Access Compliance Report Public Rights-of-Way (Curb Ramps)

Main Street: N/A		Cross Street: WINDMILL_AVE		Location:	E
ADA ID: RPRK211110113717	Ramp Type: Type 4 - Parallel	Initial Pass/Fail: Fail	Overall Compliance: No	Severity Score:	15

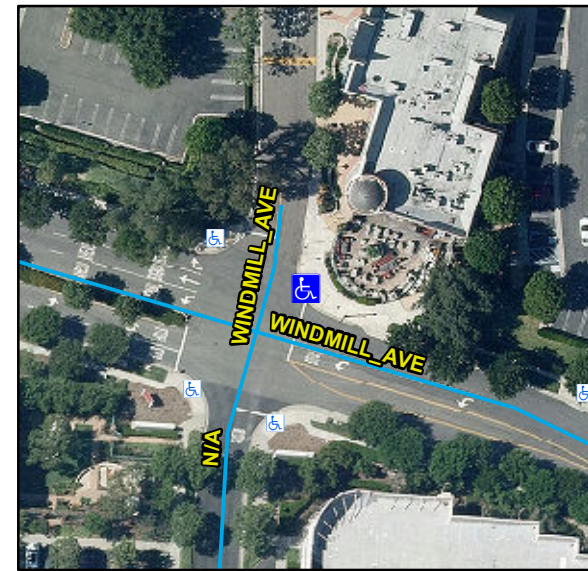
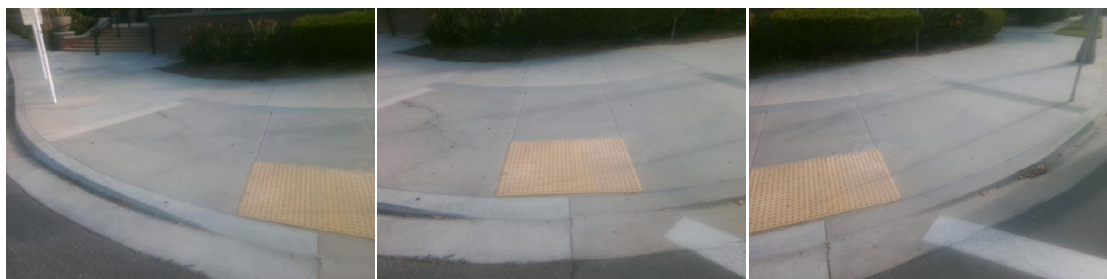
Compliance	Description	Data	Compliance	Description	Data
N/A	Ramp Length LT (in)	103	N/A	Ramp Length RT (in)	104
Yes	Ramp Width LT (in)	96	Yes	Ramp Width RT (in)	96
Yes	Ramp Run Slope LT (%)	2.4	Yes	Ramp Run Slope RT (%)	7.3
No	Ramp Cross Slope LT (%)	4.6	No	Ramp Cross Slope RT (%)	5.3
N/A	Landing Present	N/A	N/A	DWS Provided	N/A
N/A	Landing Length (in)	N/A	N/A	DWS Contrast	N/A
N/A	Landing Width (in)	N/A	N/A	DWS Length (in)	N/A
N/A	Landing Run Slope (%)	N/A	N/A	DWS Full Width	N/A
N/A	Landing Cross Slope (%)	N/A		DWS Offset Type	N/A
N/A	Landing Movement Obstructed?	N/A	N/A	DWS Offset Left (in)	N/A
	Landing Movement Type	N/A	N/A	DWS Offset Right (in)	N/A
N/A	Landing Shared	N/A			
N/A	Clear Space	Yes			
N/A	Clear Space To Crosswalk (in)	N/A			
N/A	Marked Crosswalk 1	No	N/A	Marked Crosswalk 2	No
	Crossing 1 Direction	NW		Crossing 2 Direction	SW
	Marked Crosswalk 1 Width (in)	N/A		Marked Crosswalk 2 Width (in)	N/A

Remove & Replace Curb Ramp With Two New Directional Ramps or Equivalent.

R304.5.3, STD 1115
